NOTICE OF BURWOOD LOCAL PLANNING PANEL MEETING

(Item DA4/25) Section 4.55(2) Modification to BD.2016.021 at 199 Burwood Road, Burwood.

Section 4.55(2) Modification to an approved four storey mixed-use development comprising of 15 units, 3 commercial tenancies, basement car park and rooftop communal open space, located at No. 199 Burwood Road, Burwood.

Figure 3: Ground floor plan of the development, as proposed by this modification application. Source: Urban Link Architects (2024).

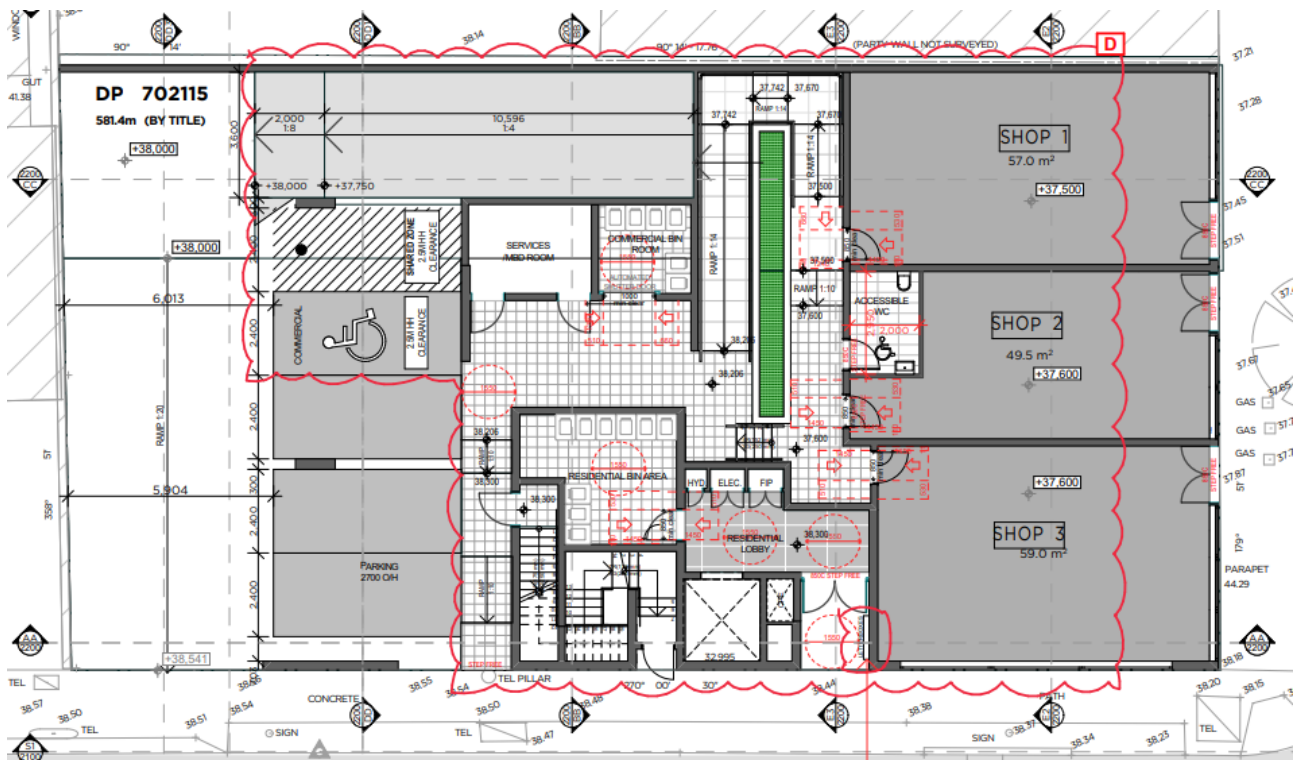
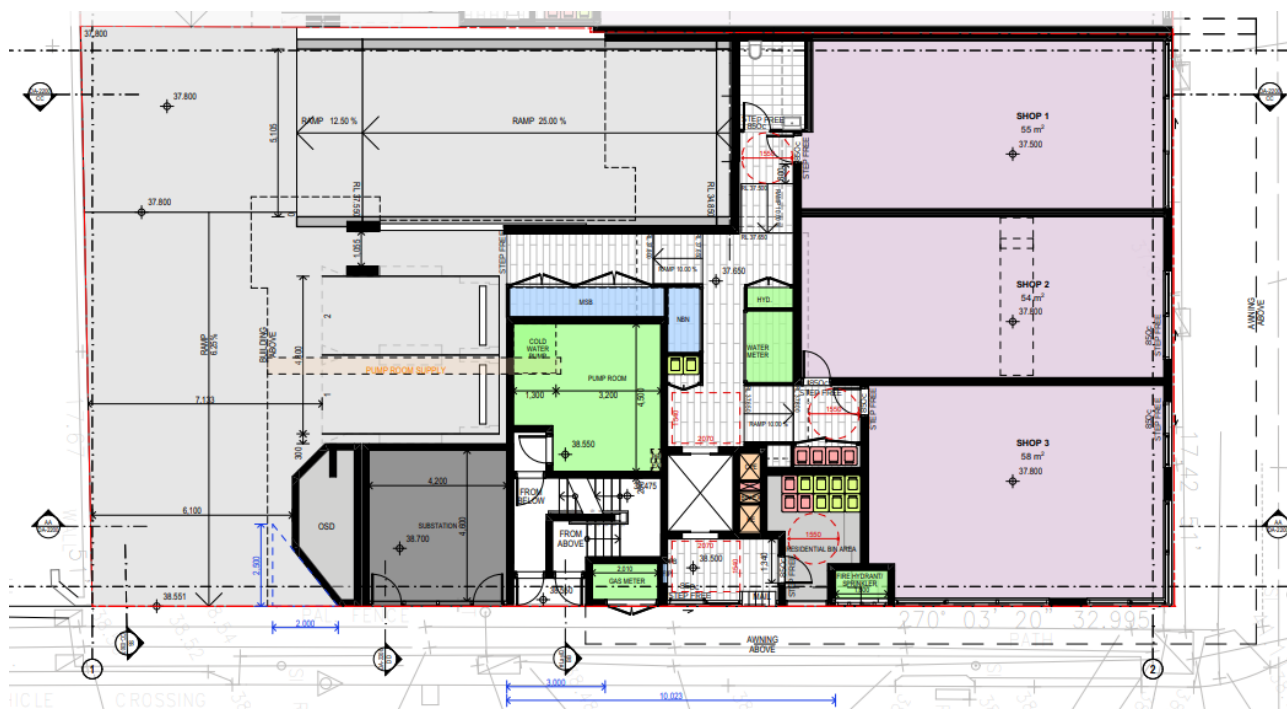
- Inclusion of an electrical substation based on services load demand calculations and approvals sought from the electricity provider. Due to the corner location of the site and with no vehicle access for maintenance from the Burwood Road, the substation must be located within the south-west corner of the building.

- Rationalising of accessible ramps.
- Accessible threshold to the residential lobby requires adjustment to RLs.
- Improvements to the design and layout of residential entry lobby with inclusion of glazing for direct line of sight to the street, adjustments to the position of the fire stair and lift core which will setback the lift overrun and stair access from the southern edge of the building at roof level.

- Increased the size of the above-footpath awning to improve weather protection to the residential lobby entrance.
- Essential services added.
- Ground floor floor-to-floor height increased by 1100mm to account for additional concrete slab thickness as recommended by detailed engineering design.

- Additional conditions of approval are recommended requiring the substation to be appropriately screened and provided with artwork to improve its appearance, that doors to the gas meter and fire hydrant/sprinkler/booster not open over the public domain, and that the external finish of the ground floor residential entry to Woodside Avenue be updated to visually distinguish its appearance from other ground floor doorways.

Figure 5: Rooftop plan of the development, as proposed by this modification application. Source: Urban Link Architects (2024).

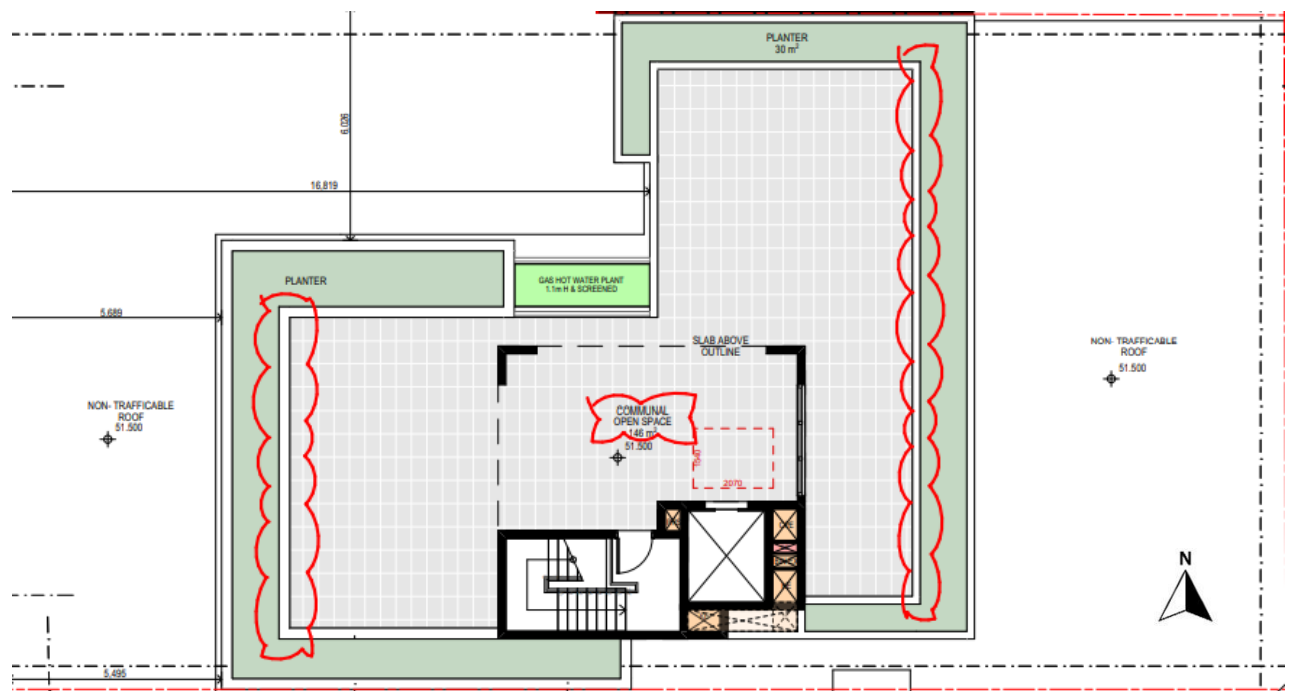
- Stair and lift core moved northward (related to improvements in the residential lobby design), and lift overrun and stair access to be less visible above the roofline.
- Essential services added.
- Additional glazing to protect lift opening from exposure to the weather.

- Additional conditions of approval are recommended requiring the east-facing door at rooftop communal open space level adjacent to the lift entrance be deleted so that is not an enclosing wall.

- An additional condition of approval requiring a modified landscape plan (inclusive of specifications and details) be submitted for the rooftop communal open space. The plan must be prepared by a qualified landscape architect and incorporate a diverse range of plant species suitable for a rooftop garden and include perimeter plantings to enhance privacy and the amenity of the rooftop.

Figure 14: Section plan of the development as proposed by this modification application, showing the increased building height including the provision of a substation. Source: Urban Link Architects (2024).

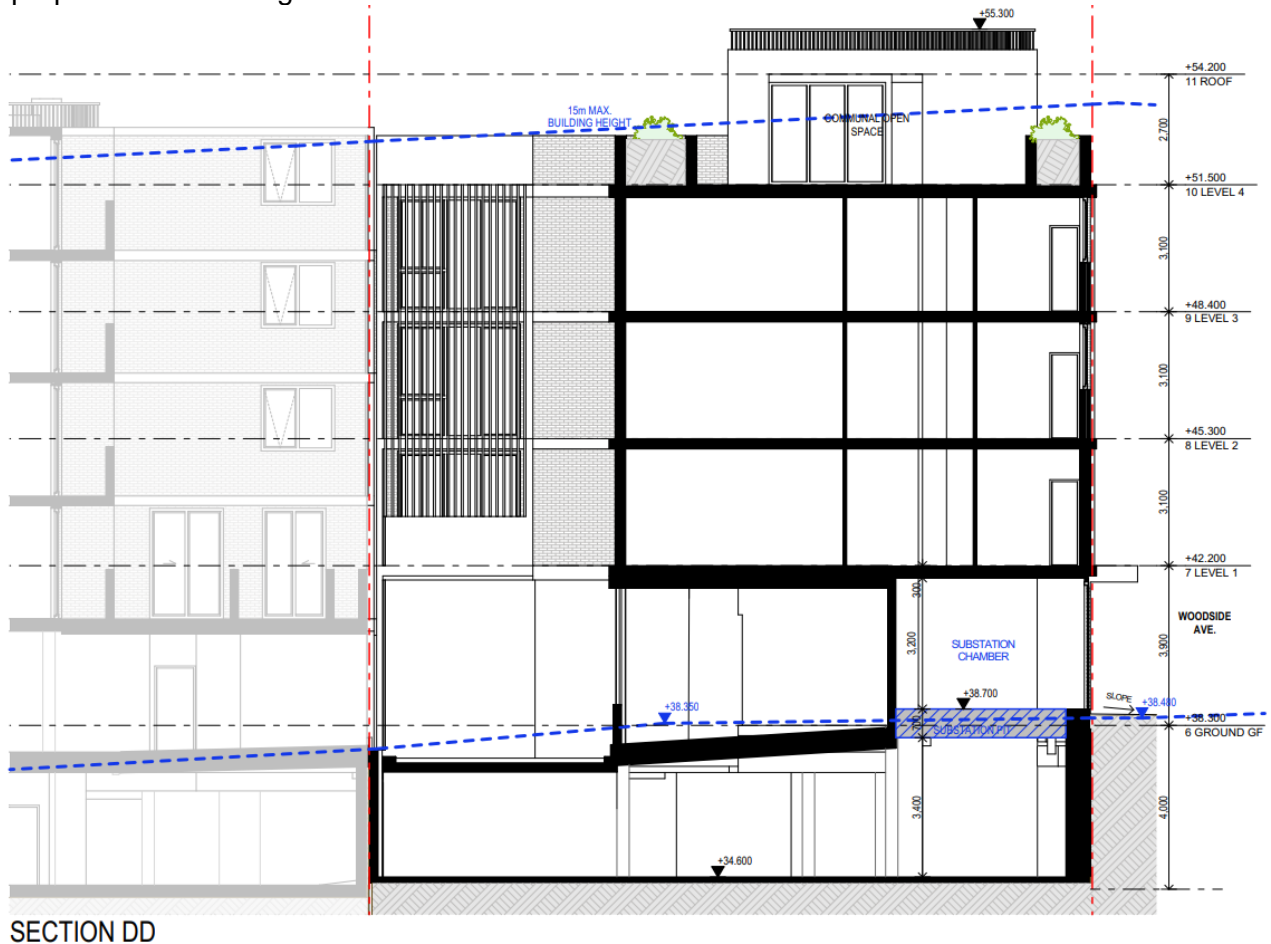
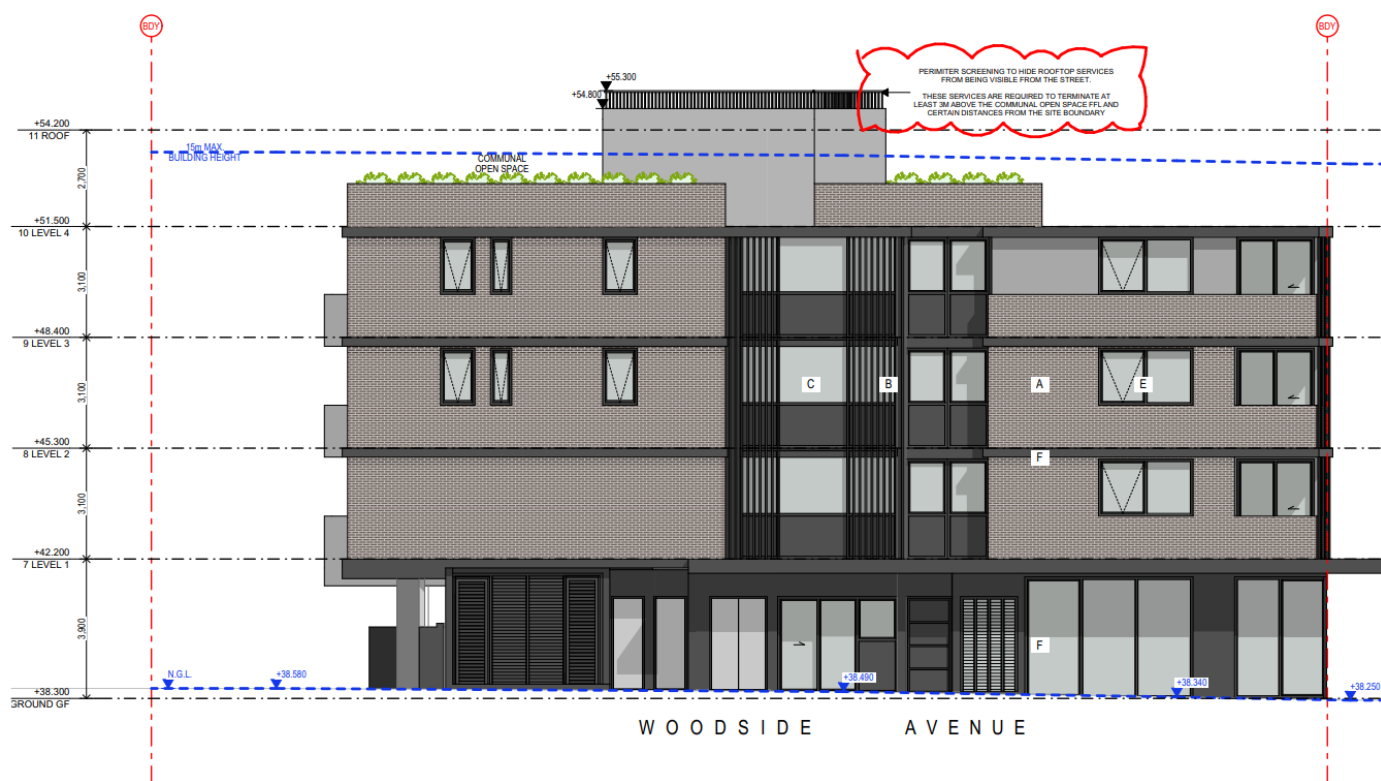
This modification application proposes to add an additional 1.1m in height to the approved building, meaning the building will exceed the 15m Height of Buildings development standard by 12.23% or 1.835m, bringing the total building height to 16.835m.

- 1) Despite the increase in height by 1.1m, the modification will improve the overall appearance and streetscape presentation of the building by moving the lift and stair overrun back away from the street frontage. The southern façade will appear less imposing and more coherent as a result of this change, along with improvements to the residential entrance and lobby and above footpath awning.

- 2) The modified lift shaft and service stair overrun is less ad hoc in appearance and is better located and integrated into the overall design of the building.
